BERKELEY COUNTY PUBLIC SERVICE SEWER DISTRICT BERKELEY COUNTY, WEST VIRGINIA

CONTRACT #10 – OPEQUON HEDGESVILLE WWTP UPGRADES

ADDENDUM #2

THRASHER PROJECT NO. 020-10042

SHEET No.	E3
-----------	-----------

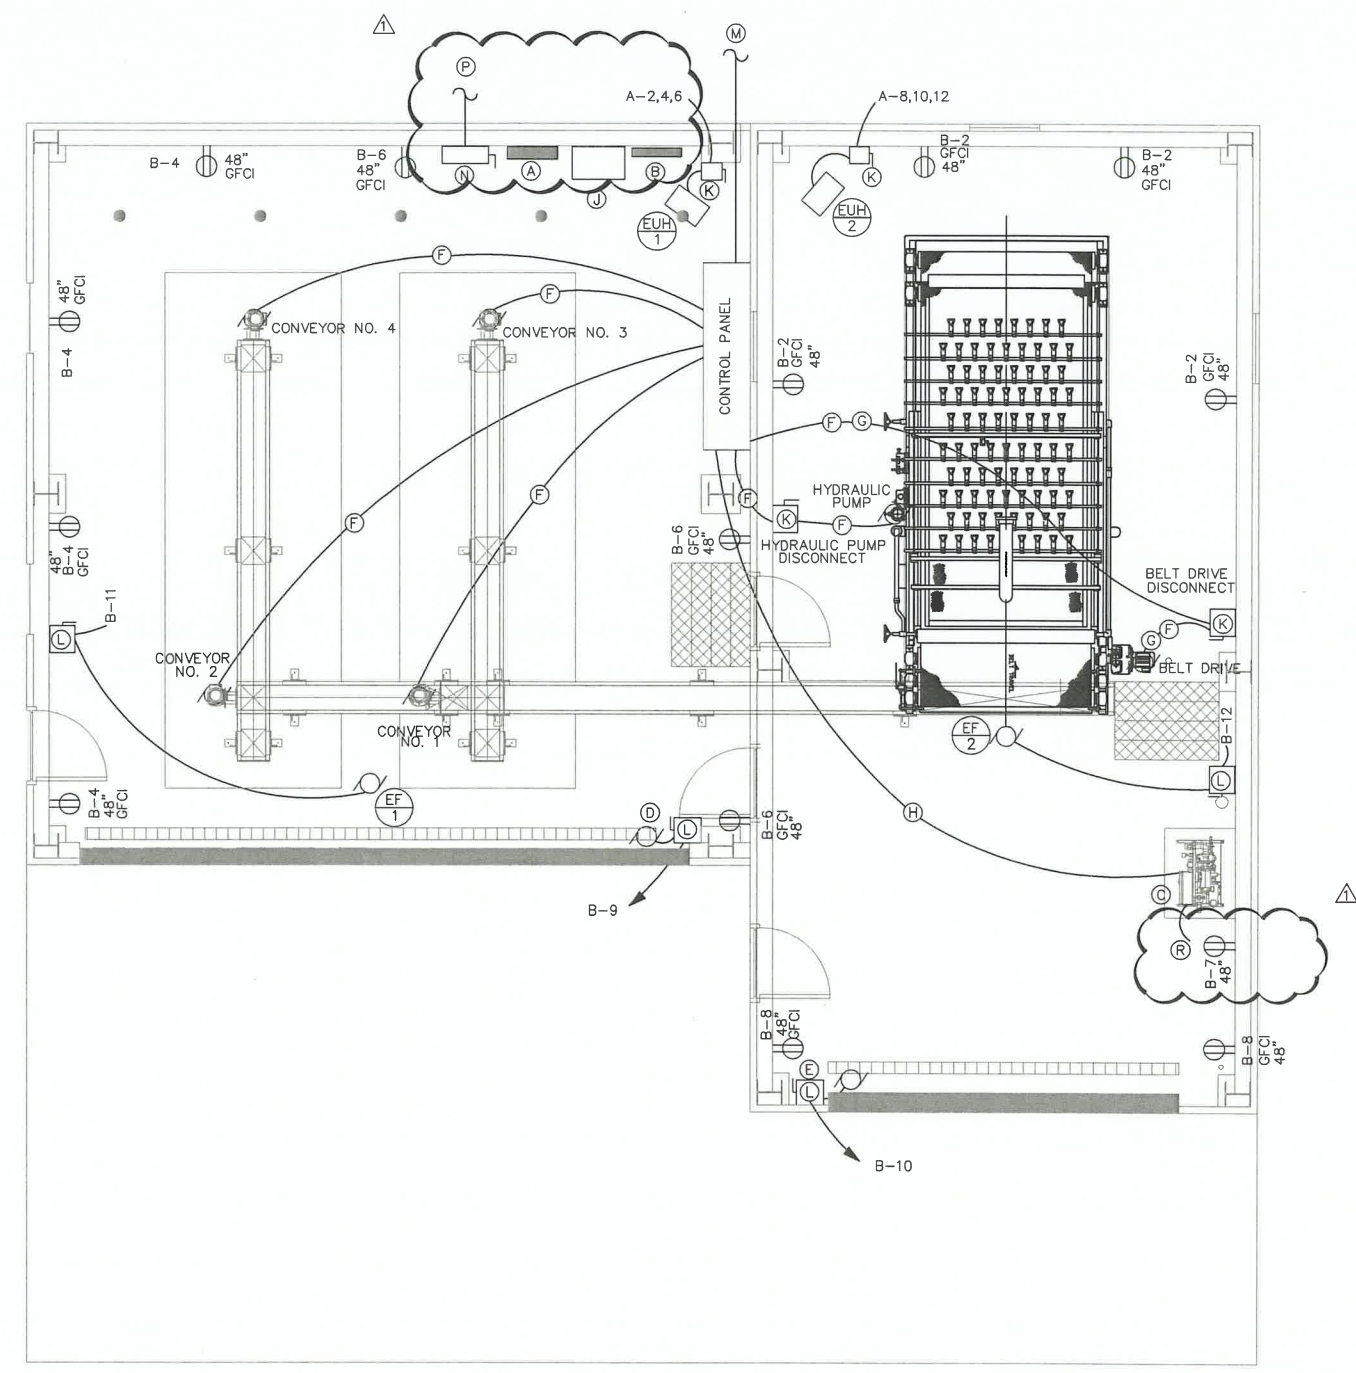
22. Screw Conveyor - Where will the control panel be located?

The electrical drawings for the location of the screw conveyor control panel will be provided in this Addendum.
